PROJECT NUMBER: 1010376 - 15DRB-70169 MINOR - PRELIMINARY/ FINAL PLAT APPROVAL

NAME: HUNINGS HIGHLAND ADDITION

**CITY OF ALBUQUERQUE
PLANNING DEPARTMENT
March 4, 2015
DRB Comments**

RE: Lot 3, Block 20, Hunings Highland Addition

**PLAT OF SURVEY
LOT 3, BLOCK 30
HUNINGS HIGHLAND ADDITION
CITY OF ALBUQUERQUE
BERNALILLO COUNTY, NEW MEXICO**

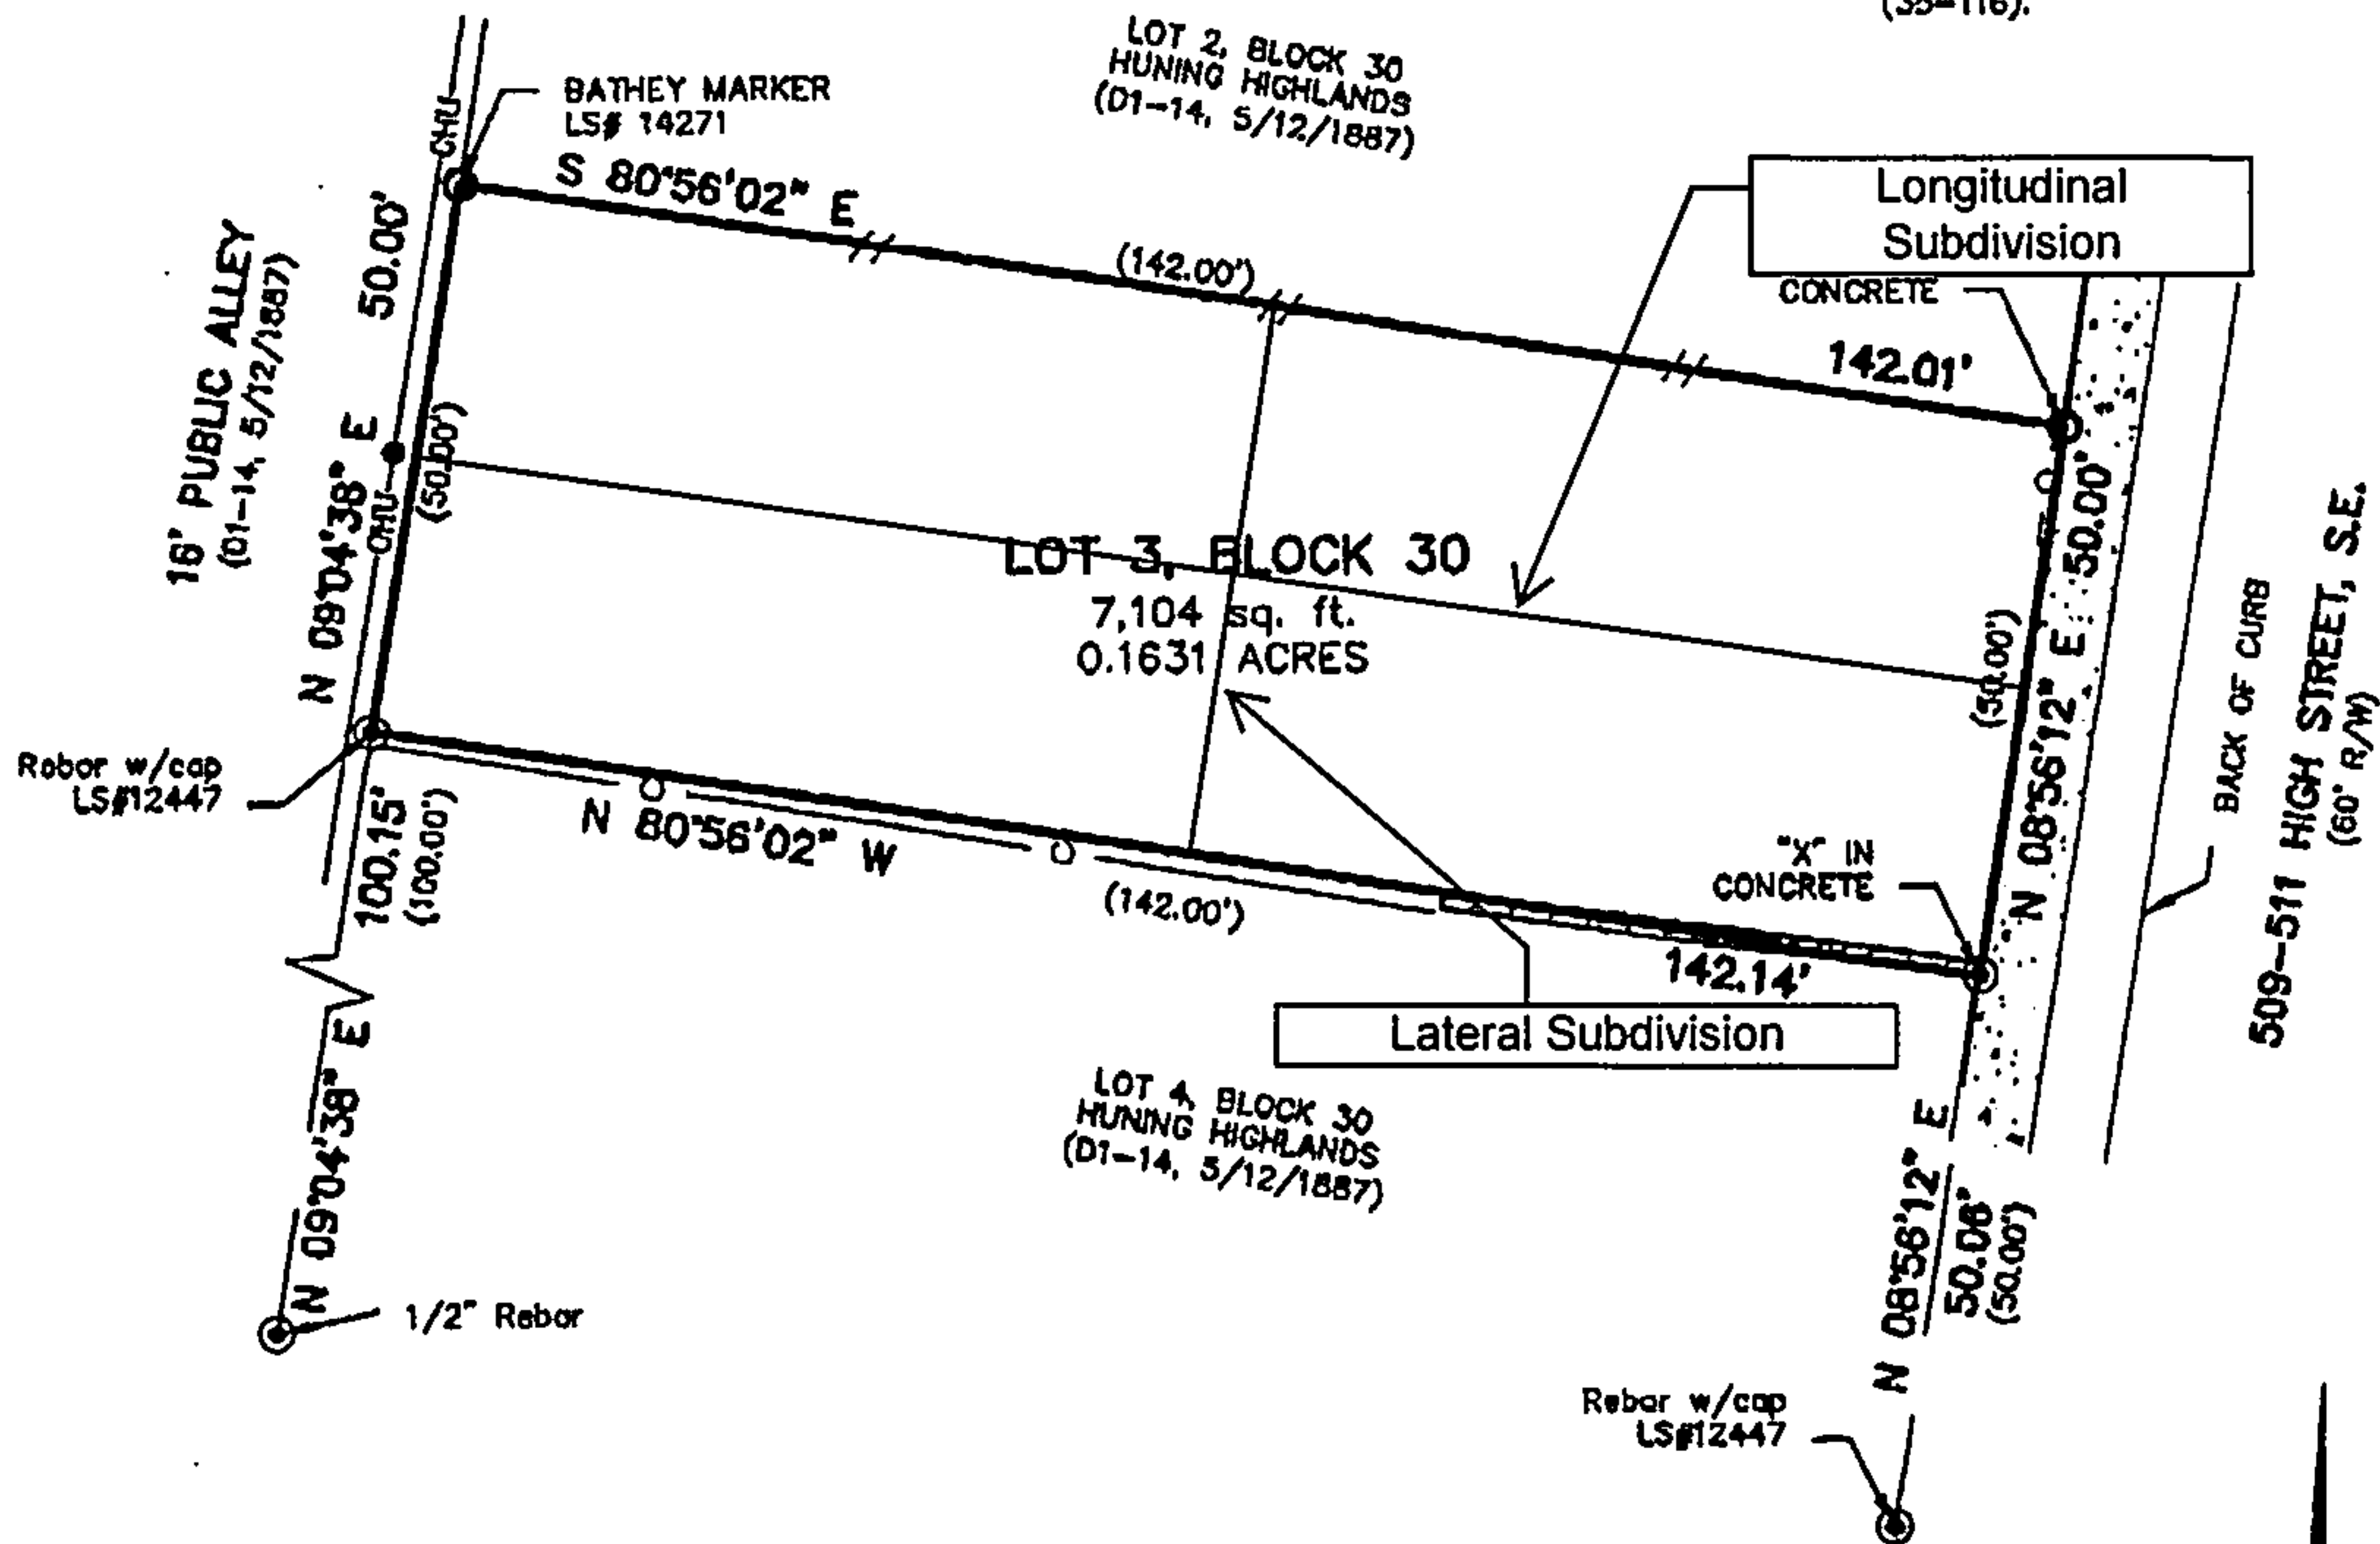
The Zoning Enforcement Officer (Brennon Williams) is the authority on interpreting the Zone Code, and what variances would be needed for the proposed development. Typically, variances to density are not allowed but rather a zone change/ sector plan amendment is required. Zoning Enforcement should verify in writing that the proposed development can proceed prior to platting.

If the tract is divided 'laterally' the project would need a variance for lack of on-site parking on the 'front' lot.

North
 1
 1
 Site Plan
 Scale: 1/8" = 1'-0"

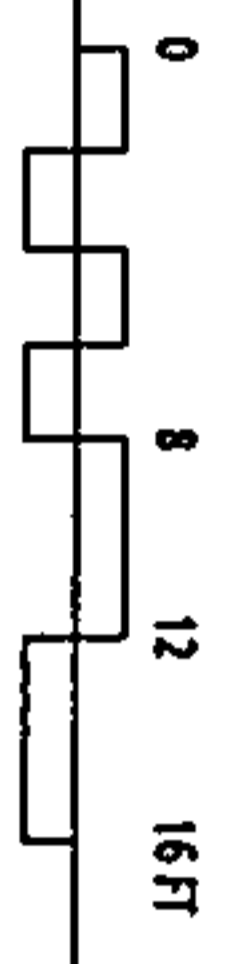
In RC, density cannot exceed 20 dwelling units per acre. $20 \times .1631 = 3.26$. Only 3 units permitted.

- Must apply for a Certificate of Appropriateness
- I believe a grading/drainage plan is required for the CoA.
- Must be heard by LUCC because of new construction
- Must be compatible in height, mass, scale, setback, geometry, materials and color with other buildings on the block

Staff questions note on site plan regarding proposed lot #2 and zone change to MR.
